1.0 INTRODUCTION

The reviews by the NRC staff and by the ACMUI have been completed, and this report provides NRC's comments and conclusions.

3.0 COMMENTS ON DRS. MARCUS' and SIEGEL'S DOSE RECONSTRUCTION

Figure(3) - Radial dose distribution around the patient in a transverse plane through stomach. All curves were calculated using the same total activity.

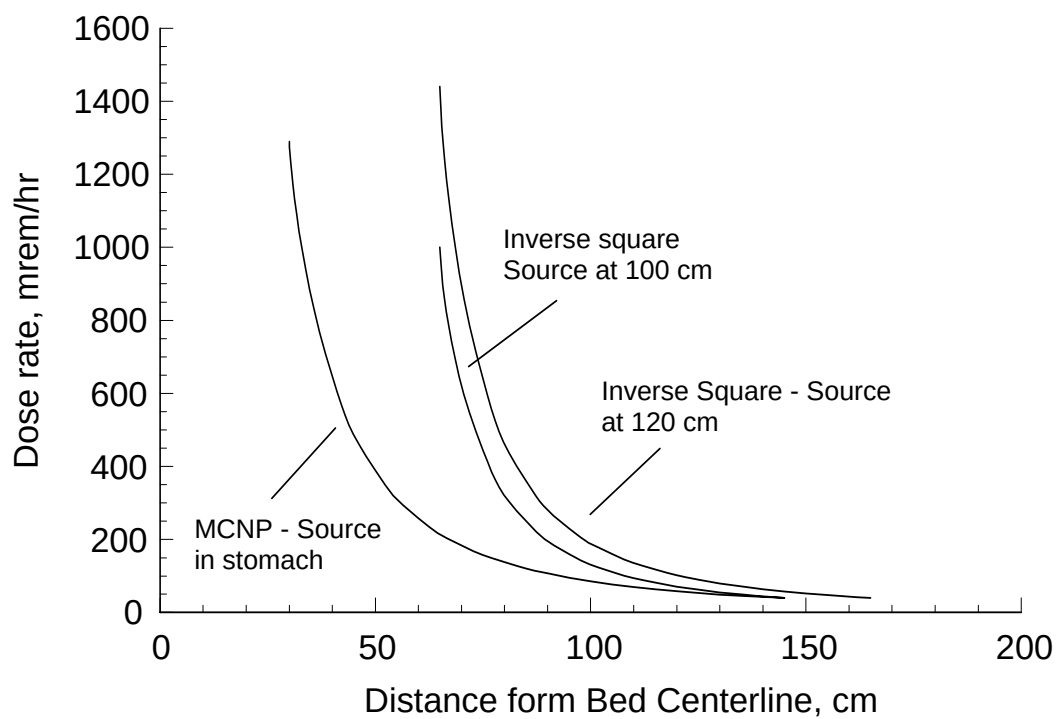
To verify this hypothesis, NMSS performed a series of Monte Carlo calculations, with each set of calculations being performed with the radioactive material located in a different organ or tissue. All calculations were performed using the same total ^{131}I activity. The results are shown in Figure (3). The calculations show the radial distribution of dose rate in a transverse plane through the center of the stomach and at a radial distance of 35 cm from the long axis of the patient. A different set of curves would have been obtained if different transverse planes were used, but the trends would be similar.

The curves clearly show that changes in the distribution of activity in the body have a very large impact on the radiation field outside the body. For example, at an angle of -90 degrees, which corresponds to the left side of the patient, the dose rate falls from about 0.5 cSv/hr (500 mrem/hr) when the activity is in the stomach, to 0.25 cSv/hr (250 mrem/hr) when it is uniformly distributed in the torso, such as in the blood pool, to about 0.05 cSv/hr (50 mrem/hr) if the activity is located in the liver. In other words, moving the activity from the stomach to the liver changes the dose rate at this location by an order of magnitude. The dose rate may also rise after it had fallen if the activity moves from the torso to the ribs and arm bones. The distributions shown in Figure (3) are idealized in that it is unlikely for all of the radioactive material to concentrate in one tissue or organ. The actual distribution would most likely be a distribution amongst a number of tissues and organs. However, the figure clearly shows that the observed changes in bedside dose rates with time were not due mainly to decay but to re-distribution. Decay would have an impact, but it would be secondary in comparison. It is therefore unwarranted to assert that the survey data contain an error, nor is it warranted to make the suggested decay corrections, which are in any case very small. The change in dose rate with time was taken into account in Region III's calculations by using the daily survey data on each day to assess the dose received on that day. The decay effects were stated in the Marcus/Siegel reconstruction to account for an NRC dose overestimation by a factor of 1.5, but based on the above considerations, NMSS believes that this factor is much smaller, and is probably very nearly one.

- (1) The modeling assumed that the ^{131}I activity was uniformly distributed in the patient's body throughout the period in question. This may not be a valid assumption, and the results of the calculations based on it may therefore contain excessive uncertainties. This is particularly important because the calculations were performed for locations that are very close to the patient. These are the locations that would be expected to be very sensitive to the details of this distribution. NMSS's more detailed Monte Carlo calculations, which permitted placement of the activity in any organ or combination of organs, showed that the assumed distribution of the ^{131}I in the organs has a very significant effect on the radiation fields around the patient. This is clearly shown in Figure(3).

Figure(1) - Variation of dose rate with transverse distance from patient centerline. The activity is uniformly distributed in the stomach.

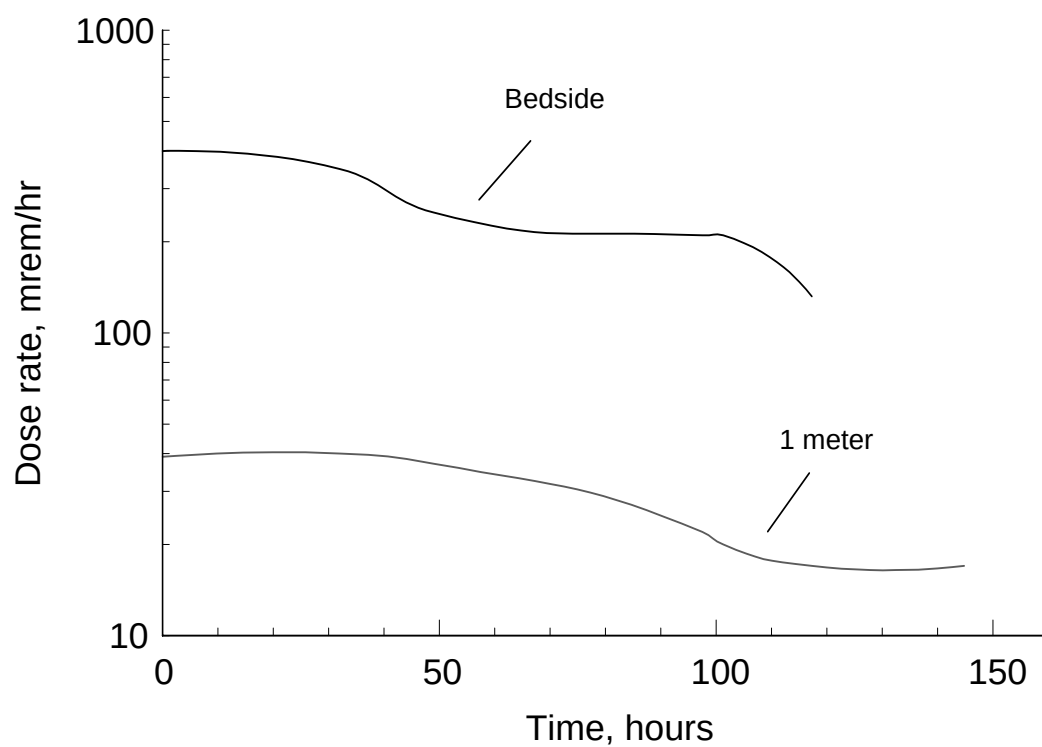
Drs. Marcus' and Siegel's reconstruction applied its analysis to the survey data taken soon after administration of the ^{131}I , at which time the activity would be located in the stomach. The Monte Carlo calculations carried out by NMSS therefore uniformly distributed the ^{131}I activity in the stomach contents. Dose rates were calculated at various distances from the patient along a transverse plane passing through the center of the stomach. The results are shown in Figure (1), together with the dose rates calculated using the inverse square law. The inverse square curves were generated using distances of 1.0 and 1.2 meters from the source, which was taken to be at bedside. The MCNP calculations were made for the left side of the patient, which was necessary because there is a considerable difference between the radiation fields on the left and right sides of the patient when the activity is in the stomach. The visitor sat on the left side of the patient.

The two inverse square curves highlight the fact that the particular inverse square curve obtained is sensitive to the assumed position of the source with respect to the survey location. The point at which a dose rate of 0.4 cSv/hr (400 mrem/hr) would be expected, according to these curves, is at about 30 cm from the edge of the bed for the lower inverse square curve, and at about 40 cm from the edge of the bed for the upper inverse square curve, assuming the source is at the edge of the bed. The curves show dose rates close to the edge of the bed that are well into the cSv/hr (rem/hr) range. Other curves could be obtained by changing the position of the source or of the "1-meter" reading location, neither of which are known exactly in this case.

In addition to its sensitivity to the exact location of the "1-meter" survey with respect to the source, the inverse square law is not valid close to a volume source, in this case the patient, and the two curves give incorrect results at all distances within a few meters of the patient, with the error becoming larger at closer distances, such as bedside. The MCNP dose rate curve shows a very different distribution from that predicted on the basis of the inverse square law, and illustrates the inapplicability of that law in this case. The dose rate at the edge of the bed predicted by the MCNP curve shown in Figure (1) is about 0.45 cSv/hr (450 mrem/hr), which is consistent with the reported "bedside" dose rate at that time of 0.4 cSv/hr (400 mrem/hr). Other MCNP curves could have been obtained by making small changes in the assumptions that went into the calculations.

Figure(2) - variation of measured dose rates at bedside and at 1 meter following administration of the I-131

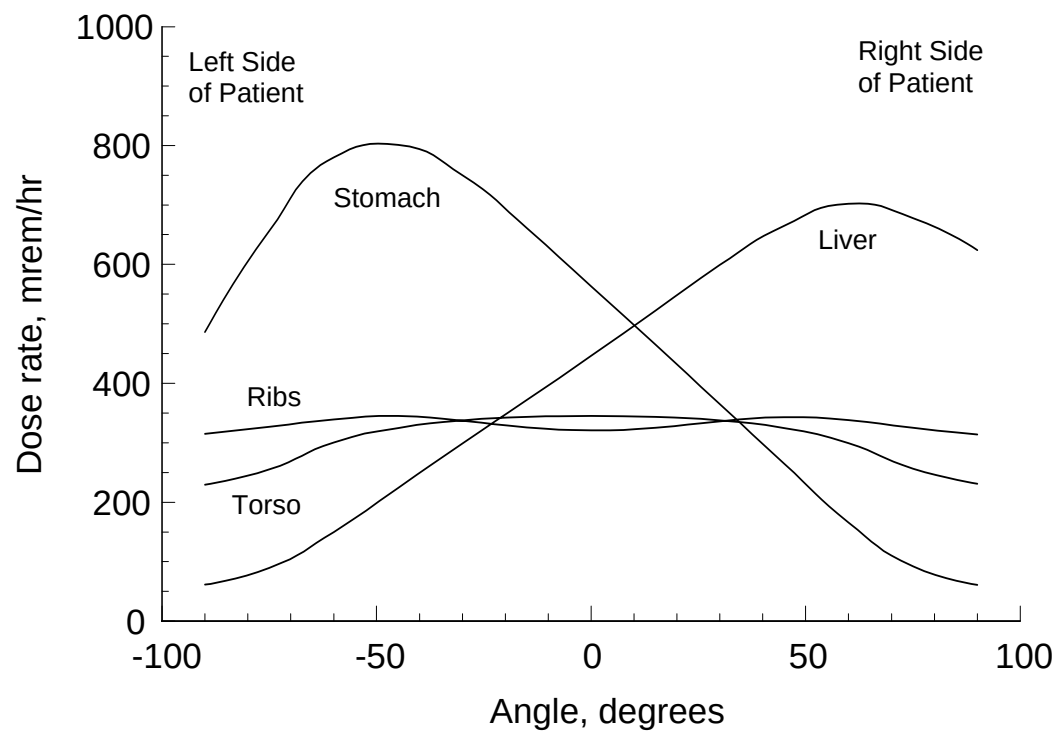
Drs. Marcus' and Siegel's report states that the survey data should have been decayed to account for exponential decay with an apparent 3.1-day half-life before being used in the dose assessments. The report also stated that "there is an obvious mistake in the dose rate on Day 4, which cannot be the same as it was on Day 3." The results of the daily bedside and 1 meter surveys made by the hospital staff during the patient's stay are shown in Figure(2). The figure shows that, although there is a general trend of decreasing dose rates, the trend is neither constant nor exponential, and is not the same for the bedside and the 1-meter readings. The decrease is uneven, and the bedside readings stabilize on days 4 and 5. An exponential decay would be represented by a straight line with negative slope in Figure (2). A half-life assignment is appropriate for an exponential function, but should clearly not be assigned to the pattern shown in Figure (2).

NMSS, however, does not believe that the observed pattern of dose rate variation with time is due mainly to decay or excretion. This is partly because the radiological half-life of ^{131}I is about 8 days, and therefore cannot account for the observed changes. In addition, the patient's renal function was severely depressed, and she was therefore not excreting the activity at a rate that would account for the observed changes, nor for the pattern of change. NMSS suspected that the observed changes in dose rate were due mainly to a re-distribution of activity in the body, which started in the stomach following ingestion, was absorbed into the blood, and was then distributed amongst the organs and tissues in the body. This distribution would be affected at least in part by the distribution of the metastatic cancer cells. The differences in the two observed patterns of change in measured dose rates shown in Figure(2) are due partly to the fact that the exact survey locations with respect to the patient probably varied somewhat from day to day, but also because the readings at bedside are much more sensitive to the details of the distribution of activity in the body than they are at 1 meter. The bedside readings would be expected to respond to changes in this distribution in a manner that is different from the readings at 1 meter.

- (2) The assumption of a 3.2 day half-life in the calculations may overestimate this effect on the calculated dose rates. As discussed in Section 3.2 above and illustrated in Figures(2) and (3), the apparent changes in survey results may not have been due mainly to decay but most likely resulted from a re-distribution of activity in the patient's body. Since the details of this distribution are not known, it is difficult to reconstruct an accurate profile of the dose rate as a function of time. Taking these changes into account is also not possible if the patient is modeled as a water-filled cylinder with uniformly distributed activity. The changes in dose rate from day to day were taken into account in Region III's assessment by using each day's survey results with that day's occupancy time to estimate the dose for that day. Any deviations due to changes in between surveys were quite small, as was shown in Section 3.2, and corrections for this effect are negligible. Assuming a constant decay half-life of 3.2 days over the exposure period may lead to errors in the result, because the dose rate did not decrease uniformly in this manner, as shown in Figure (2) above.
